## ADDENDUM NUMBER 2 TO THE CONTRACT DOCUMENTS

Date: March 25, 2021  
JACOBS Project No.: 674133CH

for the  
**2016 AMP06 - Leeds Parkway Drive Pump Station SSO Abatement**

REPLACEMENT OF ROADWAY STRUCTURE (TRENCHED CROSSING)

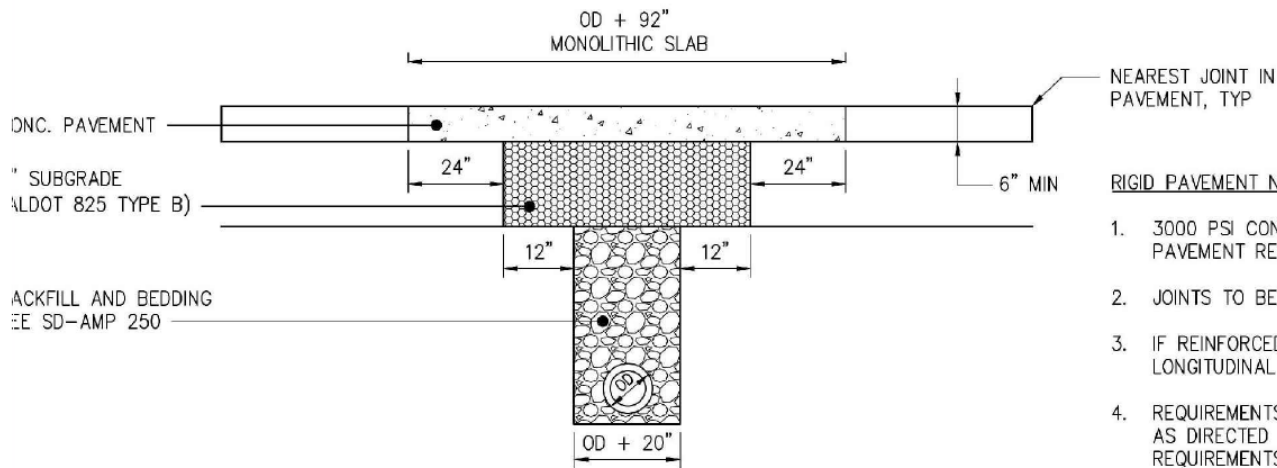
#	Question	Answer
1	Please provide clarification as to the ARV you are requiring. The specs detail the type of valve but not the size.	The ARE model number D-023 is 3-inch. 3" for Val-Matic.
2	Please provide a detail for ALDOT and non-ALDOT paving.	See attached pavement detail. Use this detail for all paving replacements / repairs.
3	What should we do with water that is pumped out of the work shafts? For example, in open cut ditch lines we will be pumping back into the ground per section 31 23 19 control of water. However, at work shaft locations such as bore pits that option will not be available.	Water should be managed similar to that in Specification Section 01 57 15, Soil and Groundwater Management, Testing and Disposal, Article 3.02.B.2, Pump Station. If after collection of water and performance of testing the water is found to consistently have a lead level lower than the drinking water standard the practice of collecting, storing and further testing can be terminated based upon approval of the Contractor's Environmental Professional since it would be reasonable to assume the water complies with the drinking water standard. This also applies to dewatering of the pump station site. Any water directly discharged shall be managed in accordance with the CBMPP to prevent sediment and turbidity from leaving the project site.

1. ASPHALT CONCRETE PAVEMENT JOINTS SHALL BE MECHANICALLY SAWED.
2. SURFACE TREATMENT PAVEMENT JOINTS SHALL BE LAPPED AND FEATHERED.
3. PAVEMENT THICKNESSES SHOWN ARE MINIMUMS. CONTRACTOR SHALL RESTORE PAVEMENT TO MATCH EXISTING CONDITIONS WHEN THICKNESSES ARE GREATER THAN THE MINIMUM SHOWN.
4. TRENCH BACKFILL, SUBGRADE, AND ASPHALT PAVEMENT PLACEMENT AND COMPACTION SHALL MEET ALDOT STANDARD SPECIFICATIONS FOR HIGHWAY CONSTRUCTION, LATEST EDITION.
5. WHEN DIRECTED BY OR APPROVED BY ENGINEER, SUBGRADE SHALL BE NO. 57 STONE.
6. REQUIREMENTS FOR TEMPORARY PAVING OF THE TRENCH SHALL BE AS DIRECTED BY THE INSPECTOR BASED ON THE LOCAL REQUIREMENTS WHERE THE WORK IS BEING PERFORMED.

1. 3000 PSI CONCRETE, HIGH EARLY CEMENT, TO BE USED FOR PAVEMENT REPLACEMENT
2. JOINTS TO BE MECHANICALLY SAWED.
3. IF REINFORCED, REINFORCING STEEL TO BE REPLACED IN KIND. LONGITUDINAL STEEL TO BE BUTT WELDED TO EXISTING.
4. REQUIREMENTS FOR TEMPORARY PAVING OF THE TRENCH SHALL BE AS DIRECTED BY THE INSPECTOR BASED ON THE LOCAL REQUIREMENTS WHERE THE WORK IS BEING PERFORMED.

**CONCRETE PAVEMENT**

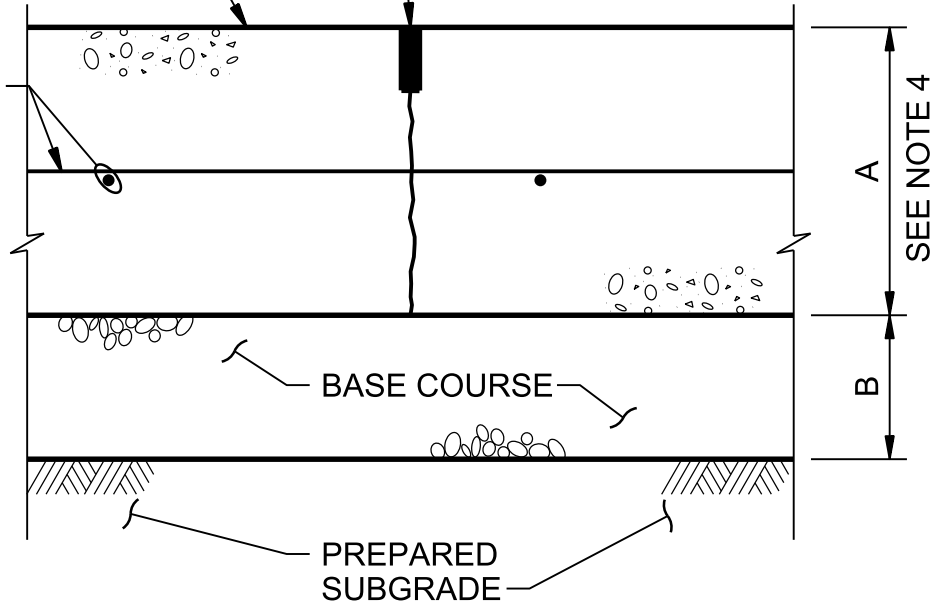
#	Question	Answer
19	2 of the 4 ARV's shown in proposal are to be inserted in existing forcemain, please confirm. If this is true please provide a detail for these two as they will require either bypassing or working during shut-down times and they will require additional DIP if ES normal detail prevails.	Assume existing tees and isolation valves can be reused. Use doghouse type manhole.
20	Which manholes are in the 100-year floodplain, which will require straps, wrap, and watertight frame and cover?	See attached manhole table.
21	<ul style="list-style-type: none"> <li>a. Section A/S-01 does not indicate a waterstop in the footing or wall. Standard Detail 0315-154 only indicates one at the wall base. Will a waterstop be required at construction joints?</li> <li>b. Section A/S-01: Will the exposed surface of the wall be required to be Rubbed or just Pointed and Patched?</li> <li>c. Spec Section 03 3010, 3.04, G. Maximum Size of Concrete Placements: Will the limits in this section apply to non-hydraulic structures?</li> <li>d. G-11: Note 1 under Foundations, states that the contractor will hire the geotechnical engineer. Is that correct or will JeffCo hire out all testing?</li> <li>e. P-01 &amp; P-02: P-01 has note: Access road, (typ each side) See Detail 2, DWG D-06. Detail 2 shows Asphalt paving. P-02 indicates these areas to be conc pavement. Which is correct?</li> <li>f. P-02 shows concrete around the stormwater equalization tank. S-05 shows the foundation of the tank to be 1'4" larger than the tank. What is the thickness of this concrete and how is it reinforced?</li> <li>g. P-02 indicates a 6" curb at the northern side of the concrete around the stormwater equalization tank. Will that curb be required at all four sides of the concrete around the tank?</li> </ul>	<ul style="list-style-type: none"> <li>a. Waterstop is not required at earth retaining wall base but is required for water holding structures.</li> <li>b. Rub and patch until a structurally sound finish that is uniform in appearance is achieved.</li> <li>c. Yes.</li> <li>d. Observations and Inspections will be provided by the Owner. All testing will be performed by the Contractor. See Addendum 1 for further clarifications.</li> <li>e. Provide concrete pavement for these areas per P-02.</li> <li>f. See attached detail 3213-240 for Concrete Pavement. Use premolded joint filler between concrete pavement and tank foundation.</li> <li>g. Include curb on all four sides.</li> </ul>

1. CONTRACTION JOINT SHALL BE MADE, CLEANED WITH COMPRESSED AIR, AND FILLED WITH SEALANT AS SPECIFIED. CUT 1" DEEP.
2. CONCRETE JOINT SPACING: EVERY 12', EACH WAY.
3. INSTALL 1/2" PREMOLDED JOINT FILLER FULL DEPTH WHERE CONCRETE PAVEMENT ABUTS CONCRETE CURB, BUILDING OR ANY RIGID STRUCTURE.
4. PROVIDE A 12" THICK BY 18" WIDE THICKENED EDGE AROUND PERIMETER OF SLAB. TRANSITION THICKENED EDGE TO NORMAL 8" THICKNESS IN 18".
